**BROWN REYNOLDS WATFORD
ARCHITECTS**

ADDENDUM NO. 03

PROJECT: LOS FRESNOS CITY HALL
LOCATION: LOS FRESNOS, TEXAS
PROJECT NO: 217072.00
DATE: July 11, 2018

The Construction Documents on the above referenced project, dated 6/11/18, shall be revised as follows:

E1.1
FIRST FLOOR POWER PLAN - ELECTRICAL

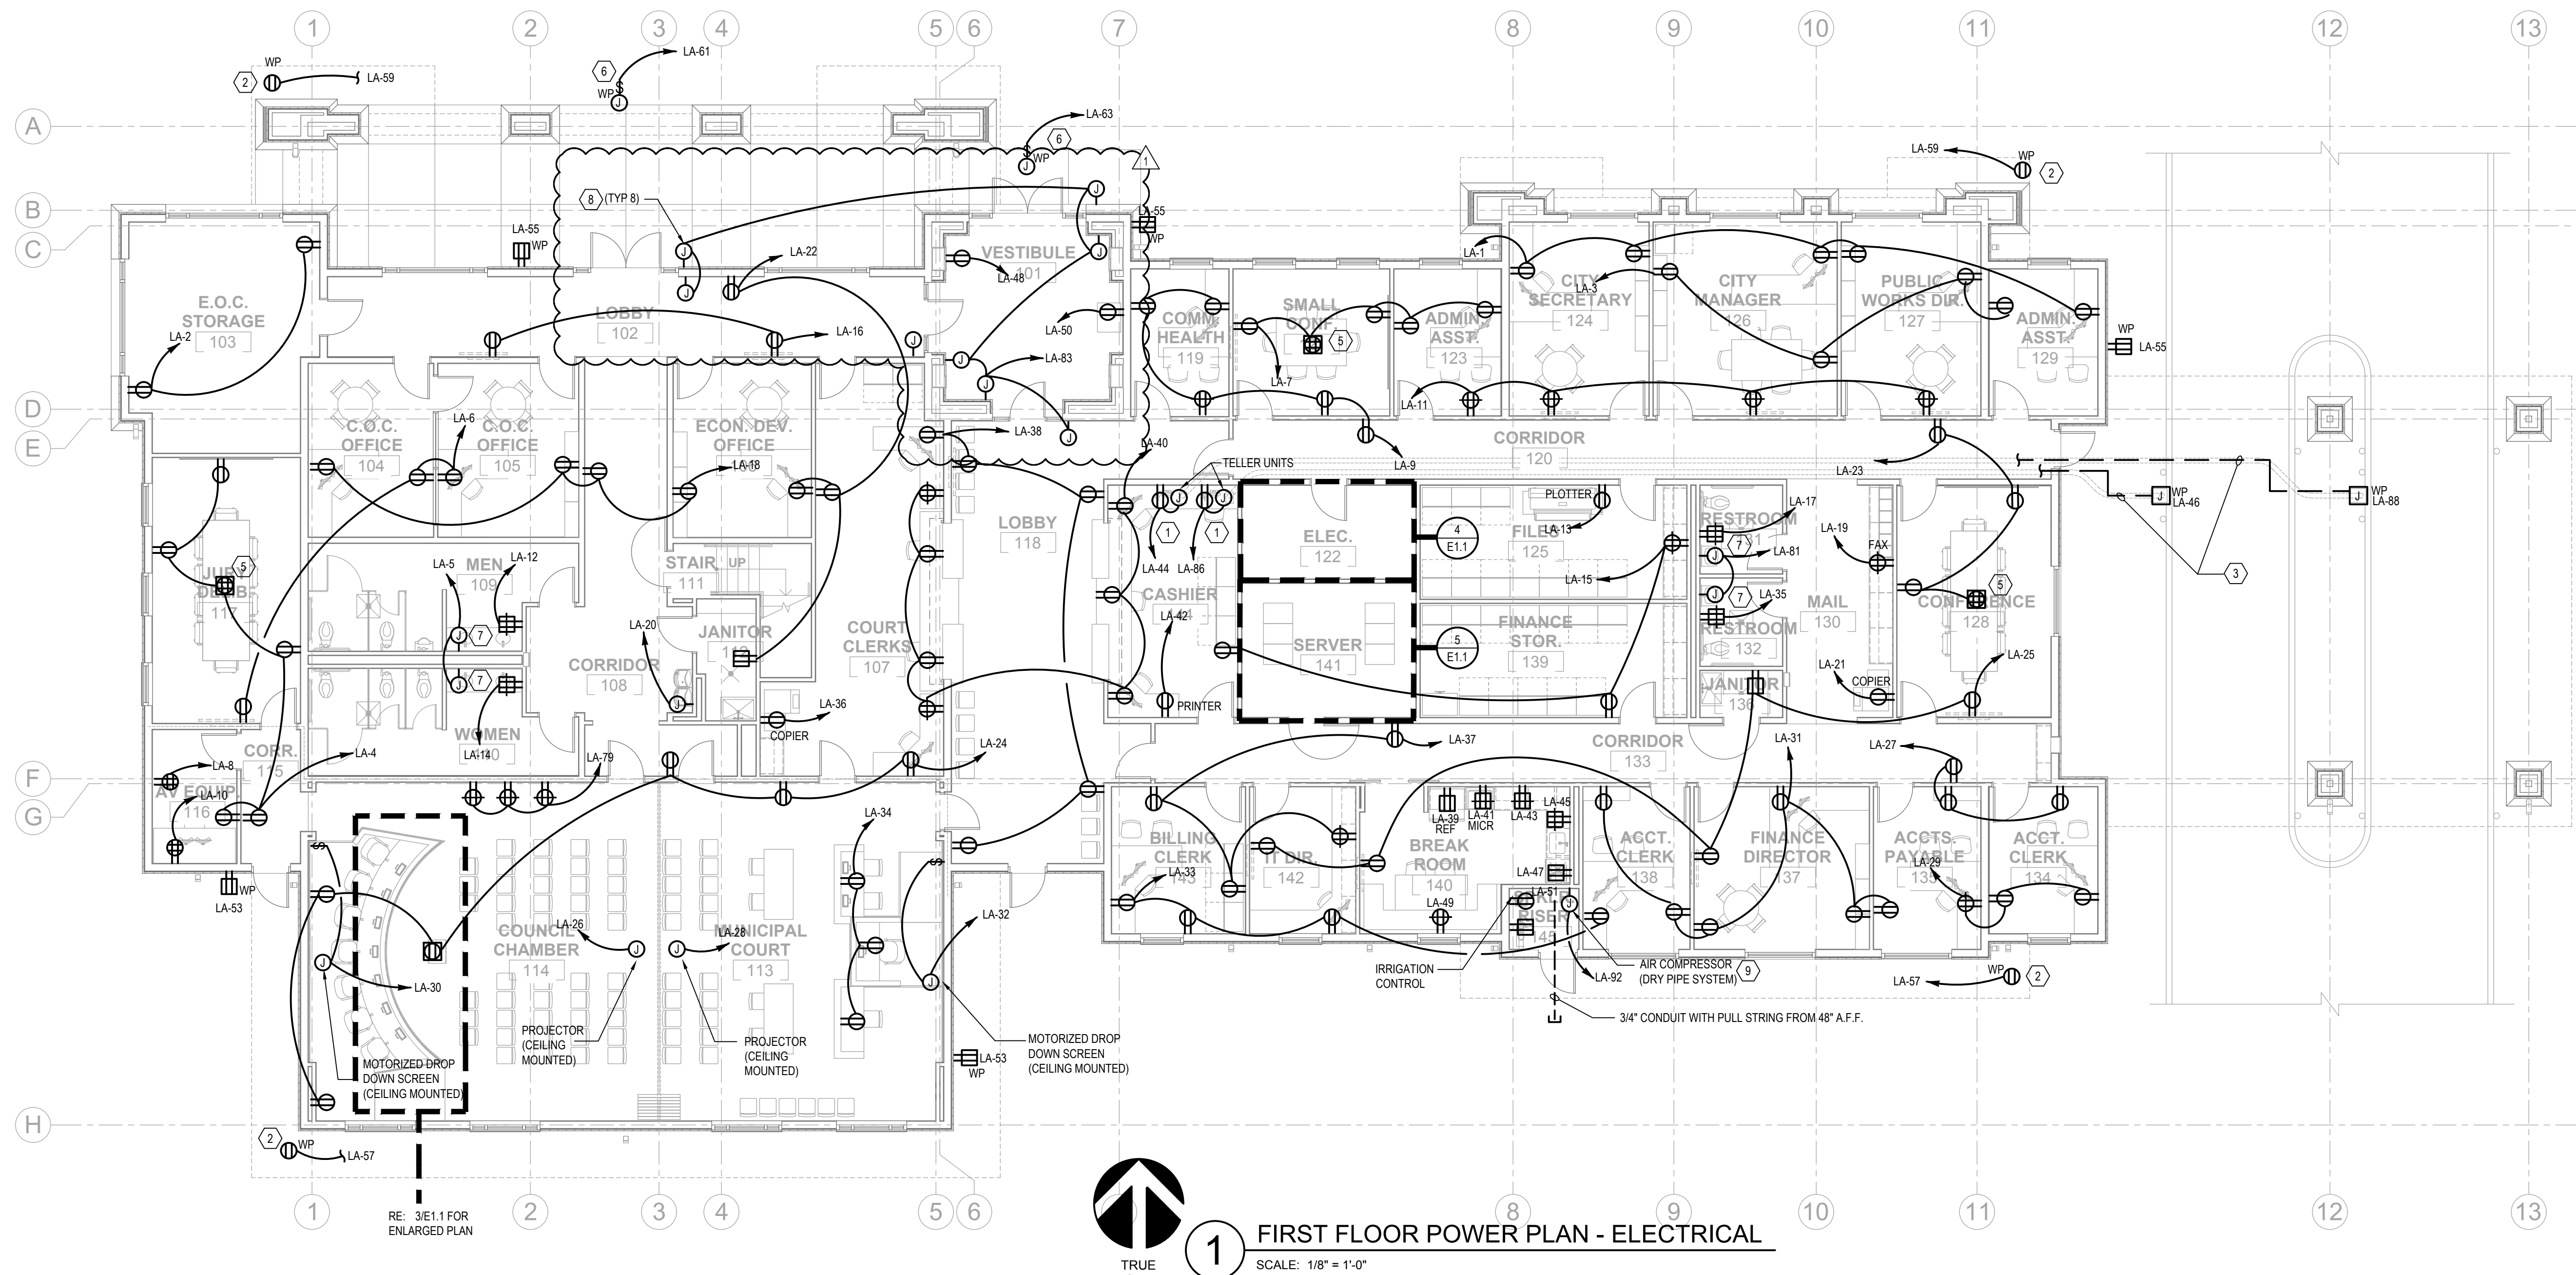
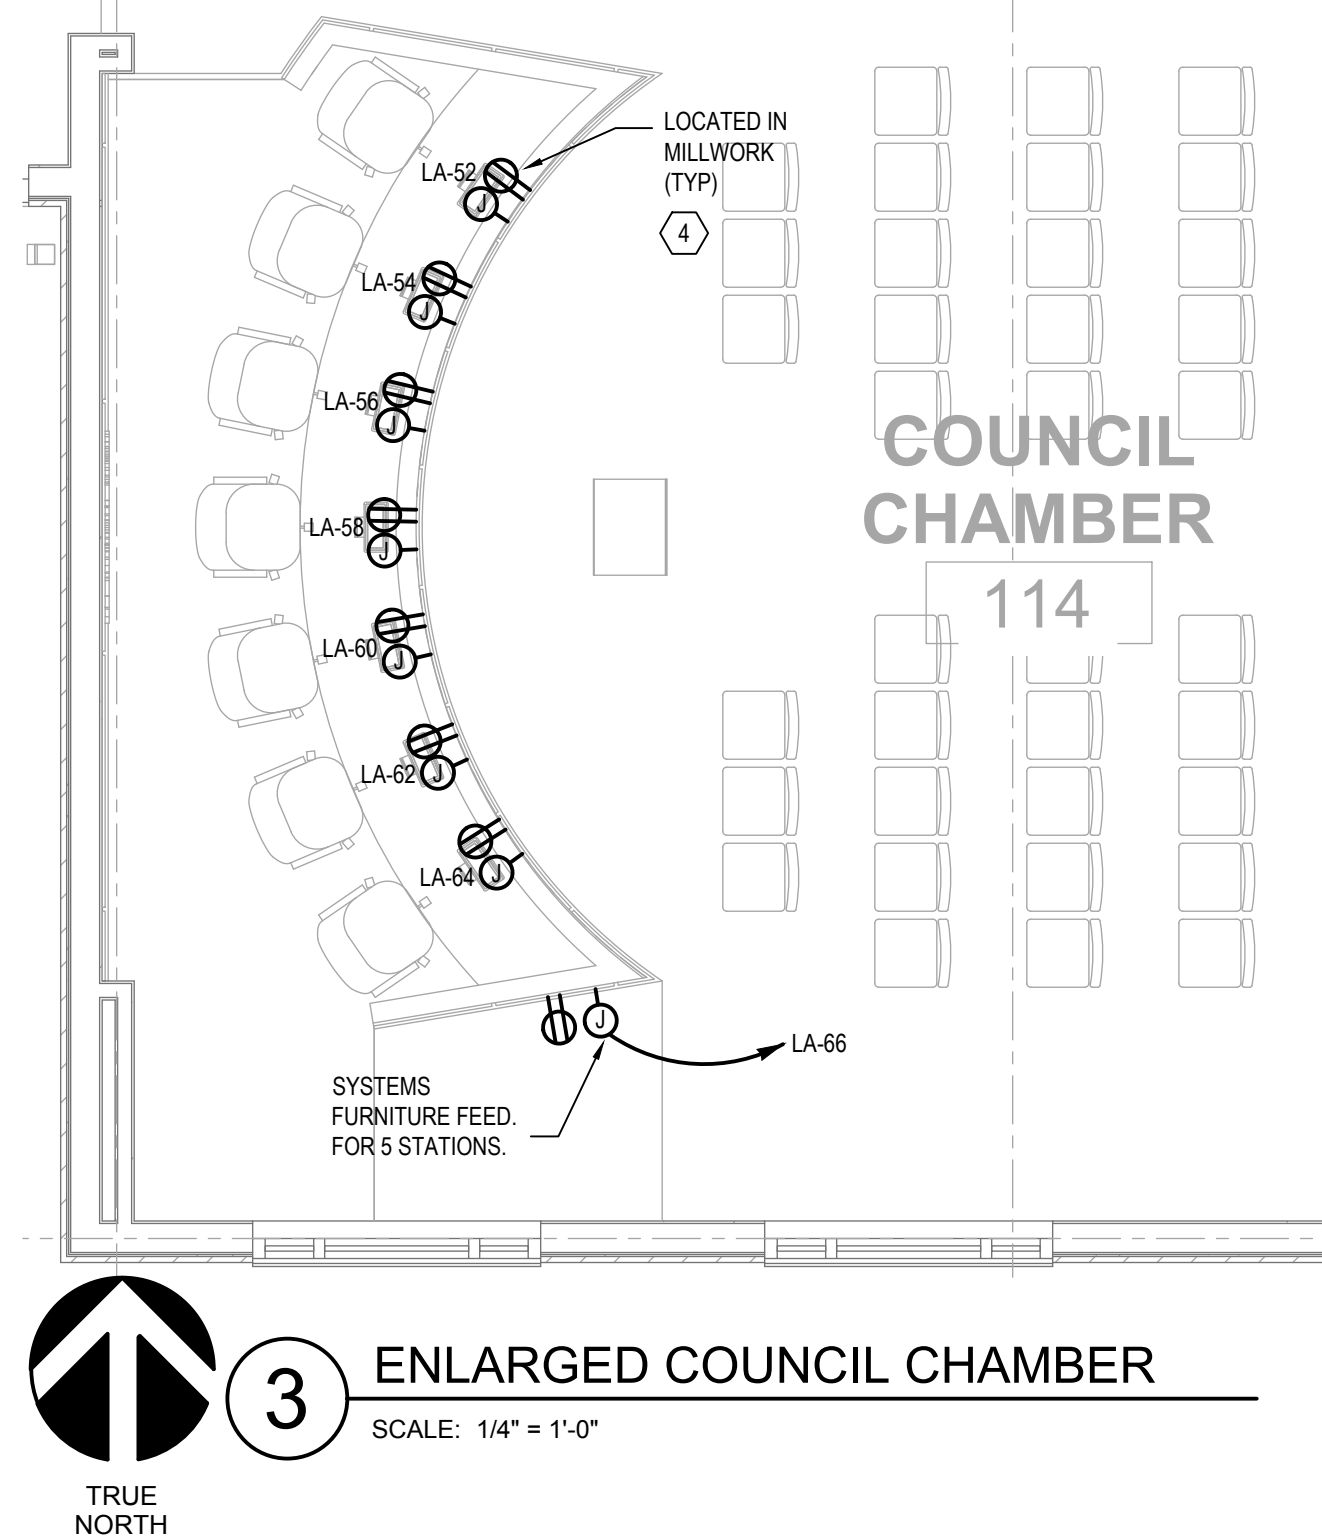
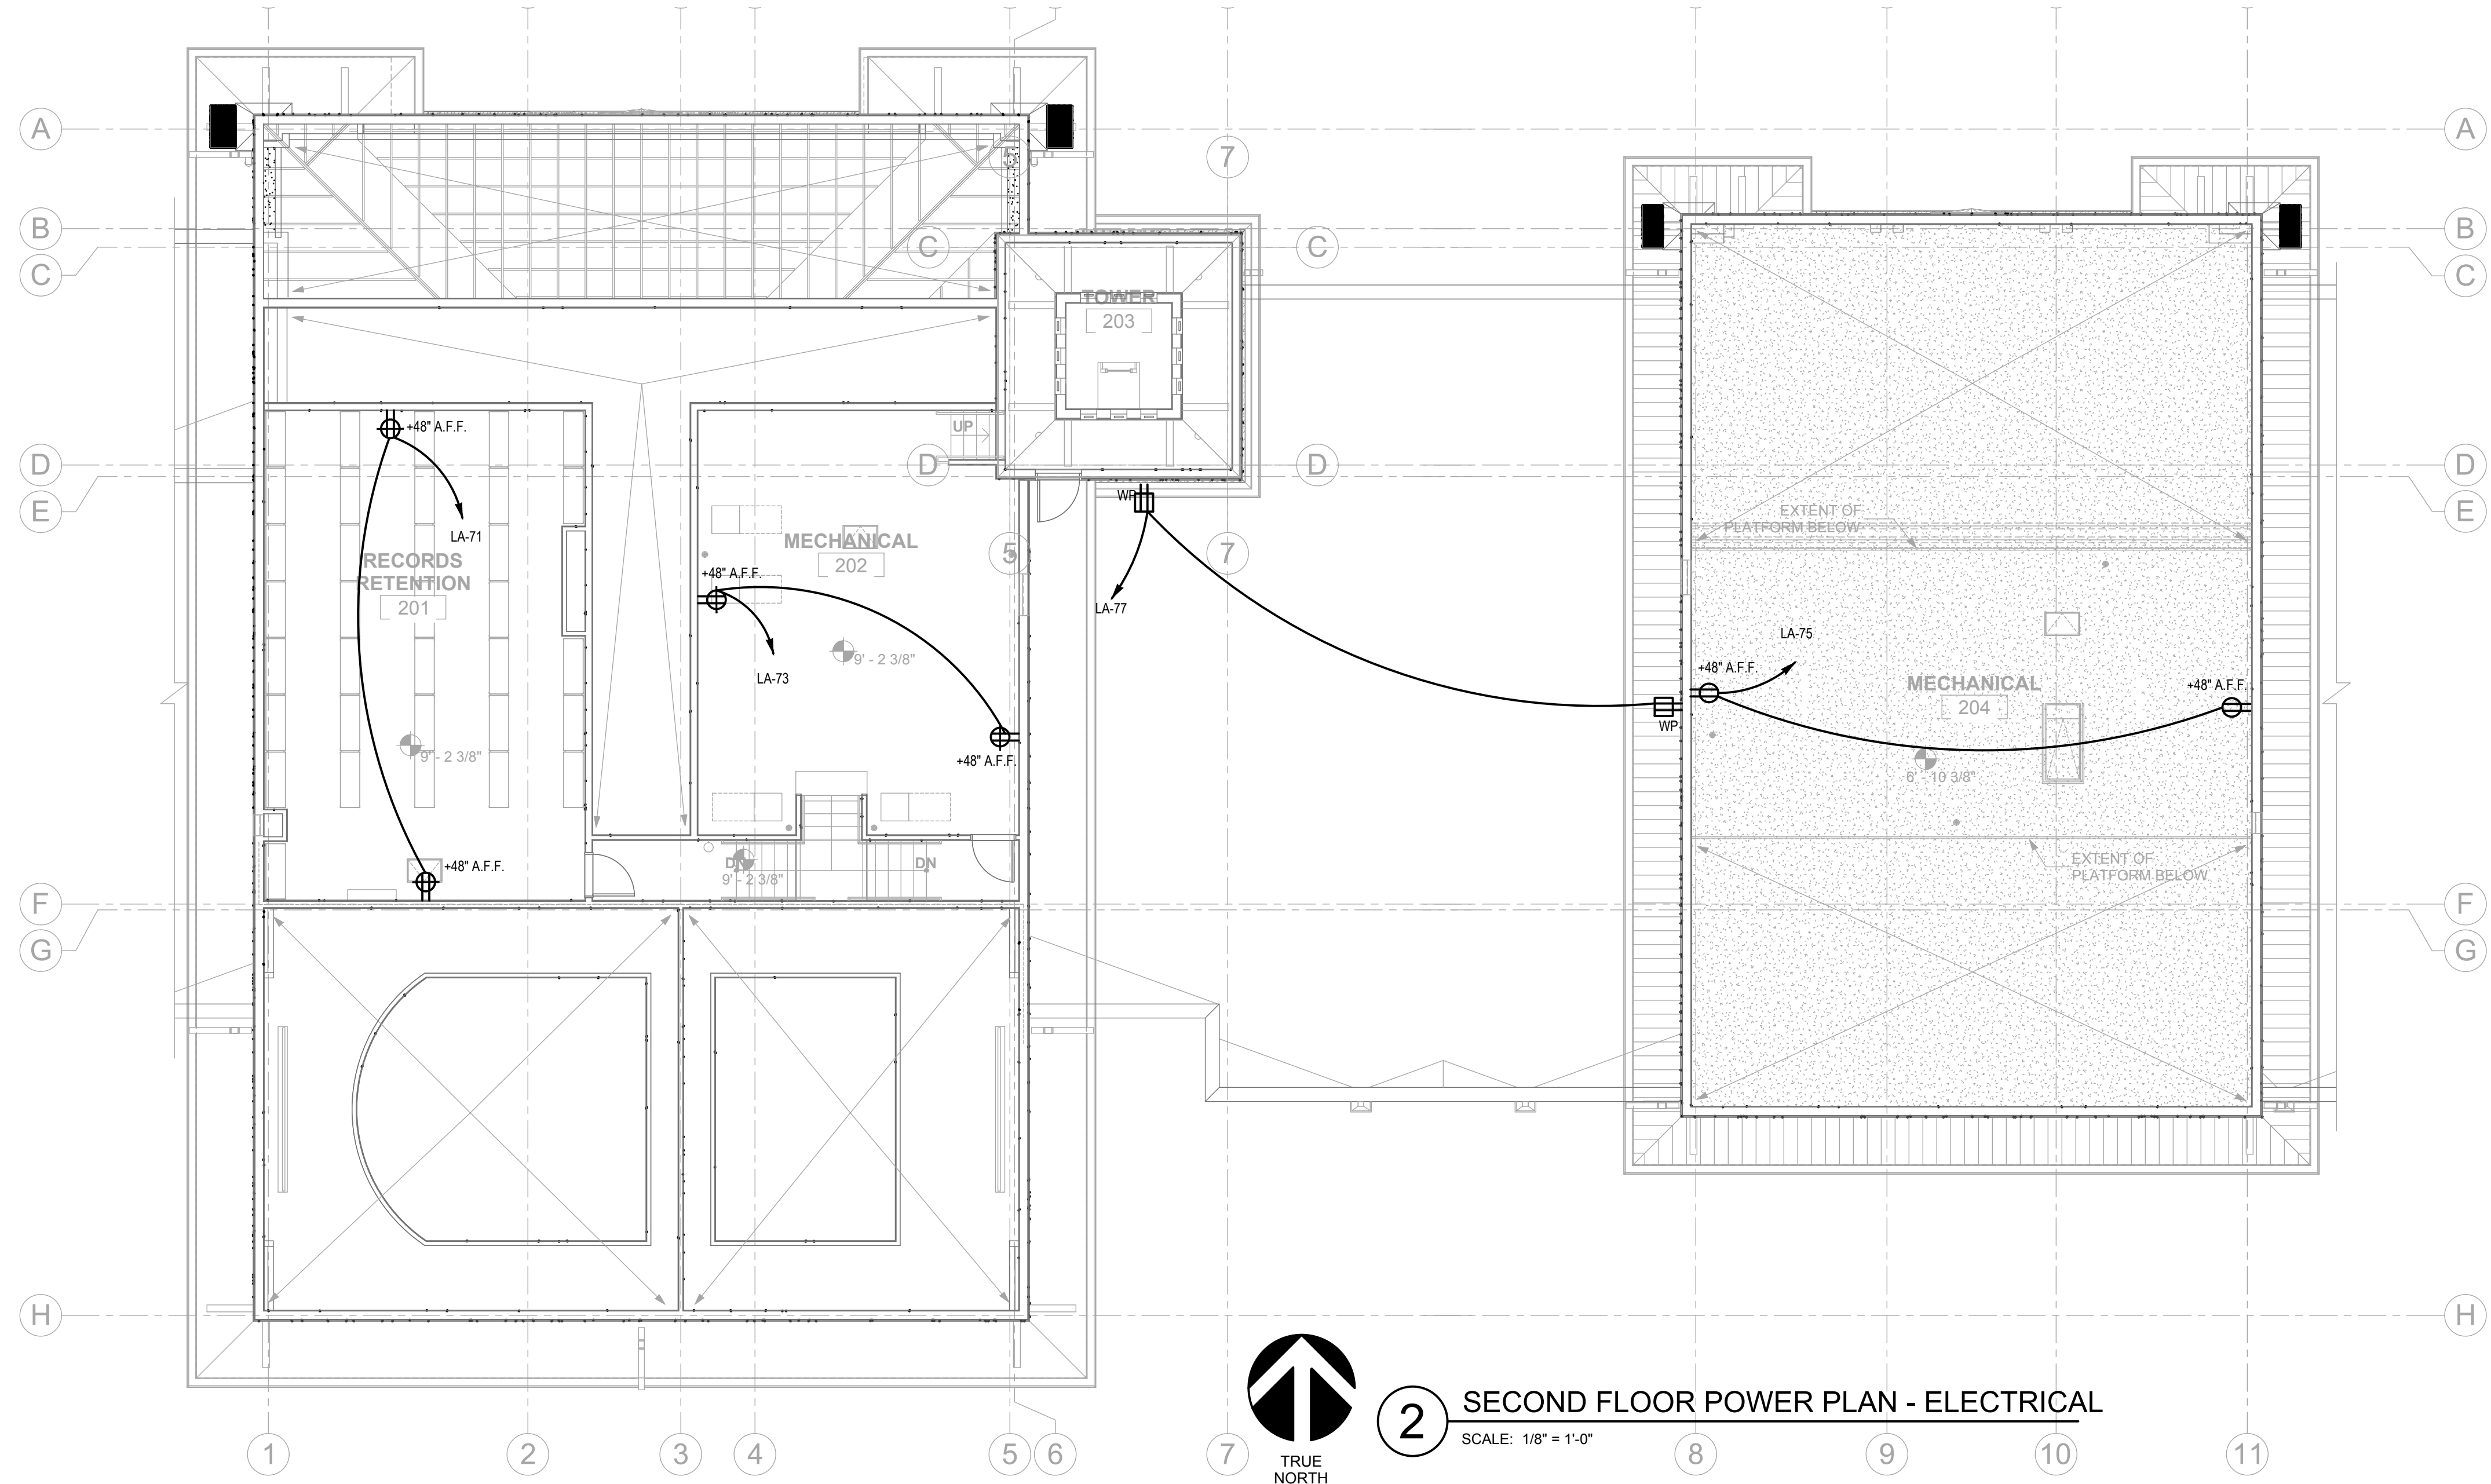
- Item No. 6** (RE: Sheet E1.1, Detail 1) – Additional push button locations for motorized door operators are added to the building interior as shown in attached revised sheet **E1.1**.
